1/4" GEN2 Disc Shuttle Valve Product Line

REV	DATE	DESCRIPTION	ORIGIN (issued by)	APPROVED
001	11-29-2016	Document No: 120-112916-001	AP	SS
002	12-17-2020	Document No: 120-112916-002	SD	
003	5-02-2022	Document No: 120-112916-003	GM	BR

Figure 1. PN 29005: 1/4" NPT GEN2 Disc Shuttle Valve, Low interflow

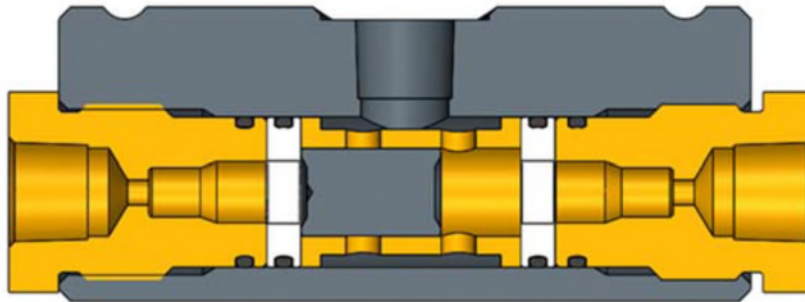
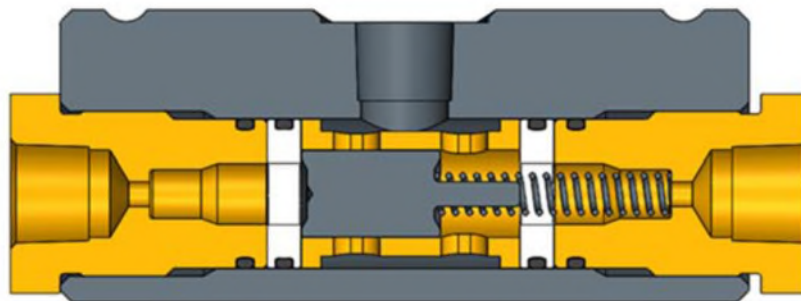
The Gilmore 1/4" GEN2 disc shuttle valve has been designed with the same footprint as the legacy Gilmore 1/4" shuttle valves. This thoroughly redesigned product line provides an improvement in cycle life and performance.

Note that GEN2 shuttle valve kits **are not** interchangeable with legacy repair kits and cannot be used in the legacy shuttle valves.
